**Re: Pio Pico Energy Center Project (11-AFC-01)  
Responses to USEPA Inquiries Related to Air Quality Modeling**

Subject: Pio Pico Energy Center PSD Permit Application  
Modeling Questions

**Pio Pico Energy Center, LLC**  
**Applicant's Responses to USEPA Inquiries Related to Air Quality Modeling**

**Figure 3**  
**Areas Where Project 24-Hour Average PM<sub>2.5</sub> Impact Exceeds**  
**Class I SIL of 0.07 µg/m<sup>3</sup>**

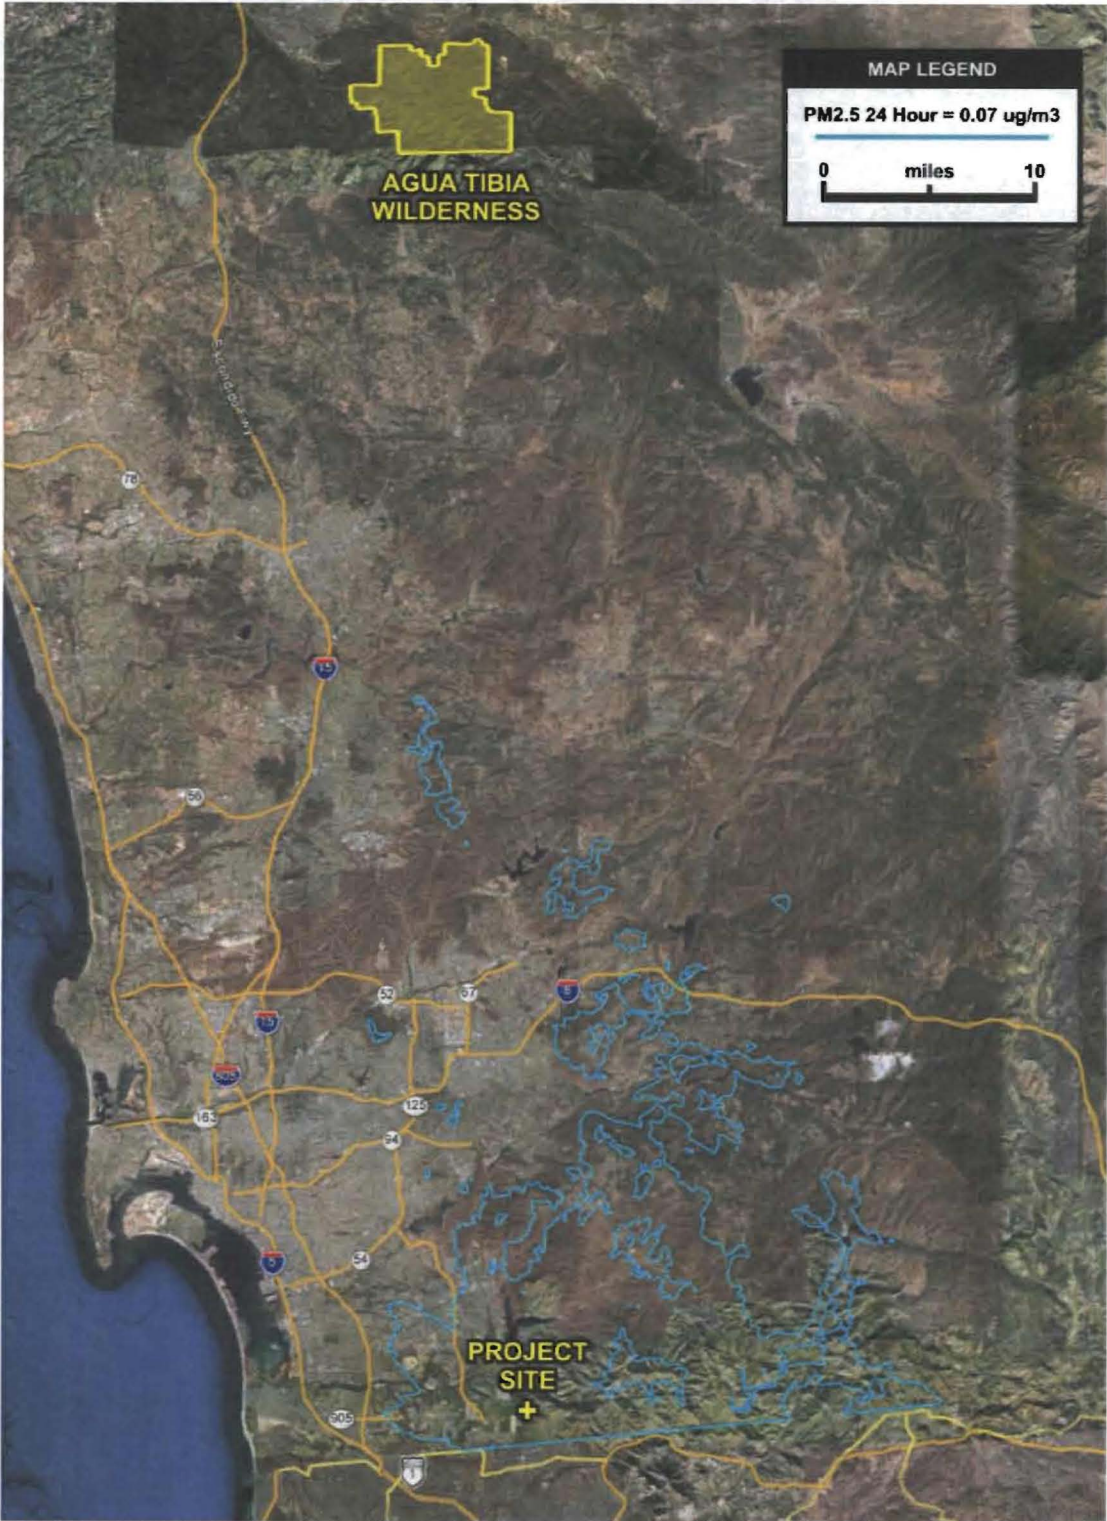
**Comment:** *Provide a Class I Increment Analysis for Class I areas within 300 km of the project site.*

The attached Figure 3 shows the areas where the modeled 24-hour PM<sub>2.5</sub> impact from the project exceeds the Class I SIL of 0.07 µg/m<sup>3</sup>. The most distant location is 52 km from the project site. The closest Class I area, Agua Tibia Wilderness, is 91 km from the project site.

Project impacts are below the SILS at Class I areas within 300 km of the project site. The project therefore does not consume increment at any Class I area.
